CITY OF CALEXICO

<u>ADDENDUM NUMBER 1</u>

Contract No. ESPL – 5168(013)

STREET REHABILITATION OF EMERSON AVENUE PROJECT

SYSTEM 3
ARHM-GG ON ARAM OVER LEVELING COURSE

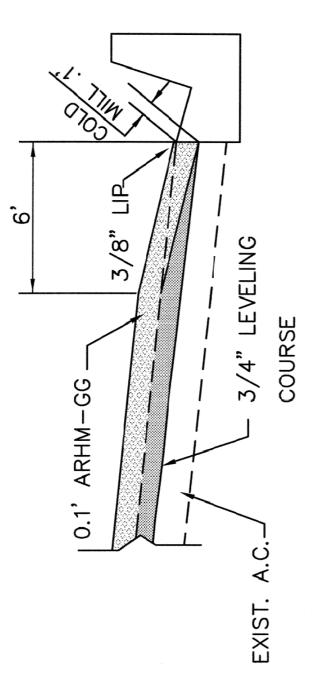
- 1. Sheets 3 through 7, **REMOVE** Keynote 1 and **REPLACE** with the following:
 - Install 0.1 feet ARHM-GG over ¾" leveling course per Detail "SYSTEM 3 ARHM-GG ON ARAM OVER LEVELING COURSE". This detail is shown on Page 8 of 10 of this Addendum.

- Sheet 7 of 9, <u>REMOVE</u> the detail labeled "ARAM SYSTEM 2 SLURRY AND ARAM LEVELING COURSE" and <u>REPLACE</u> with <u>Detail</u> "SYSTEM 3 ARHM-GG ON ARAM OVER LEVELING COURSE". This detail is shown on Page 8 of 10 of this Addendum.

SYSTEM 3 STOP POINT

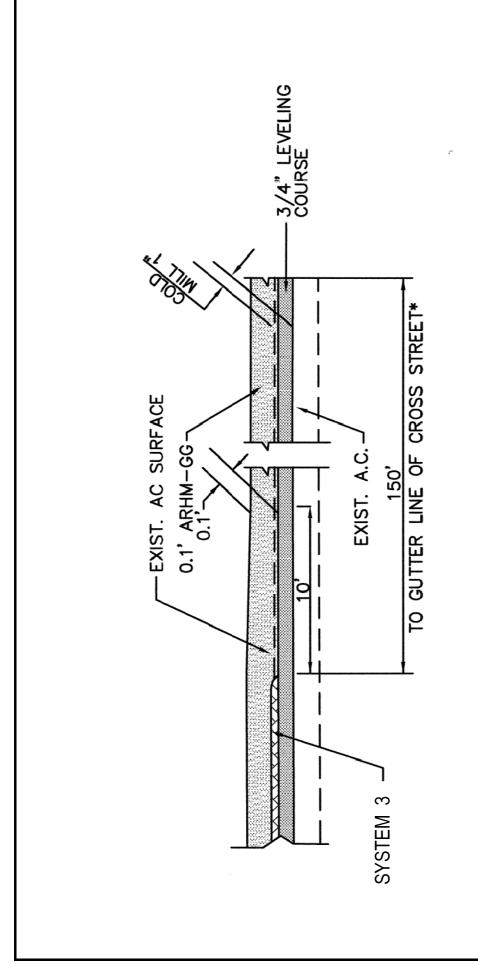
- 2. Sheets 3 through 7, REMOVE Keynote 8 and REPLACE with the following:
 - Install 0.1 feet ARHM-GG over 3/4" leveling course per Detail "SYSTEM 3 STOP POINT". This detail is attached to this Addendum.

- 4. Sheet 7 of 9, **REMOVE** the detail labeled "ARAM SYSTEM 2" and **REPLACE** with Detail "SYSTEM 3 STOP POINT". This detail is attached to this Addendum.
